#### Airworthiness Directives; Sikorsky Aircraft Corporation Helicopters

**SUMMARY:** We are adopting a new airworthiness directive (AD) for Sikorsky Aircraft Corporation (Sikorsky) Model S-92A helicopters. This AD was prompted by the manufacturer's analysis of engine data that revealed the data was inaccurate in dealing with available above specification engine power margin. This AD requires revising the Operating Limitations section of the Sikorsky Model S-92A Rotorcraft Flight Manual (RFM). The actions are intended to prevent the use of inaccurate engine performance data in calculating maximum gross weight by revising the Operating Limitations section of the RFM.

**2012-08-01 Sikorsky Aircraft Corporation:**

Figure 1. Cat 'A' Takeoff and Landing Gross Weight

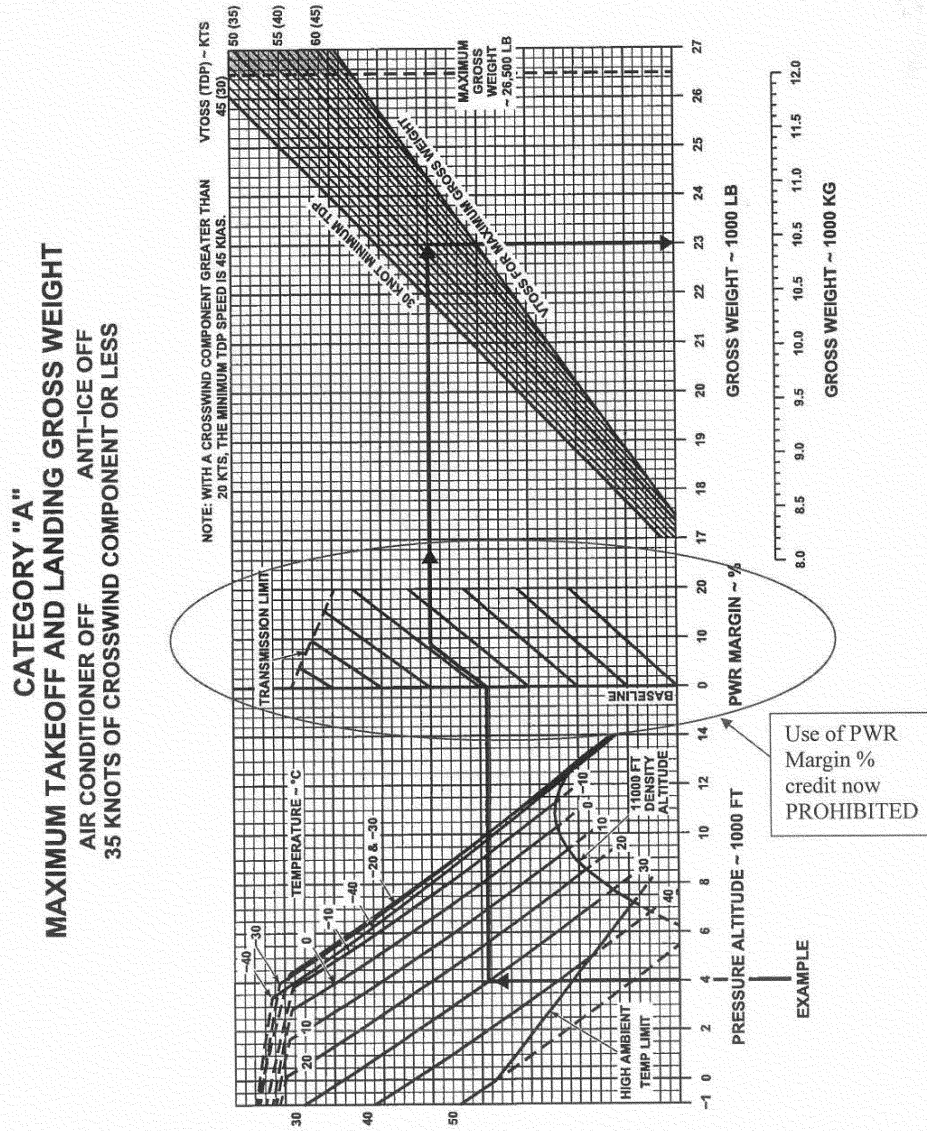
(2) If the RFM already contains the revisions appropriate for your helicopter as listed in the following Table 1, all dated April 9, 2008, with the correct performance charts, without the performance credit as depicted in the circled area of Figure 1 of this AD, the operating limitation required by paragraph (1) of this AD does not need to be inserted into the RFM.

**Note to paragraph (e)(2) of this AD:**  
Previous RFM revisions allowed for the use of above-specification engine power margin as depicted in the circled area of Figure 1 of this AD.

(1) By making pen and ink changes, insert into the Operating Limitations section, Part 1, Section 1, Weight Limits, of Rotorcraft Flight Manuals (RFMs) SA S92A-RFM-002, -003, -004, -005, and -006 the following limitation “Performance credit for above specification engine power margin is prohibited.”
